REMARKS

APPLICATION No. 09/737,402
AMENDMENT DATED SEPT. 29, 2004
REPLY TO OFFICE ACTION OF JUNE 29, 2004
ANNOTATED SHEET SHOWING CHANGES (SHEET 1/4)

FIGURE 2A

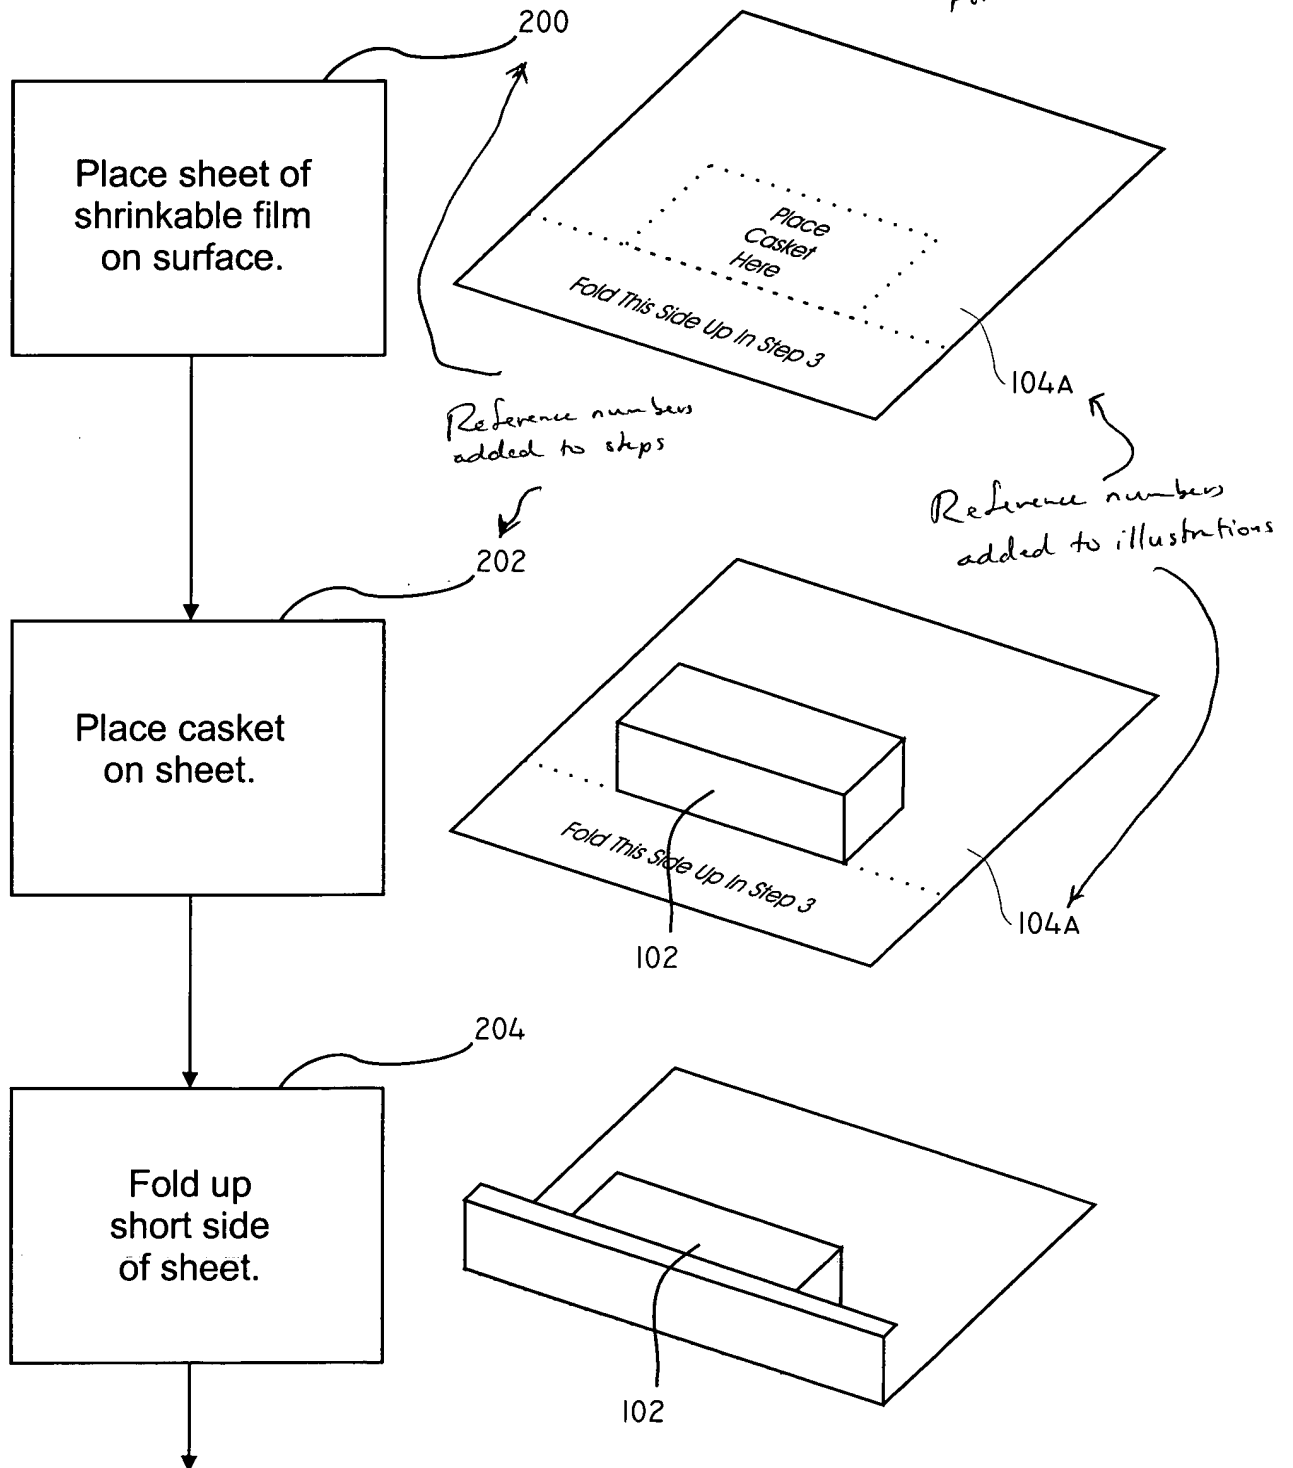
New Figure 2 corresponds to previously submitted Figure 1, however has been amended to provide flow diagram formatting illustrating the organization of the steps, as well as reference numerals for the steps and elements illustrated in the Figure. Furthermore, original Figure 1 extended across two pages, while new Figure 2 extends across three pages (sheets 2-4).

Previously Figure
1, with prior steps
placed in flow chart
format.
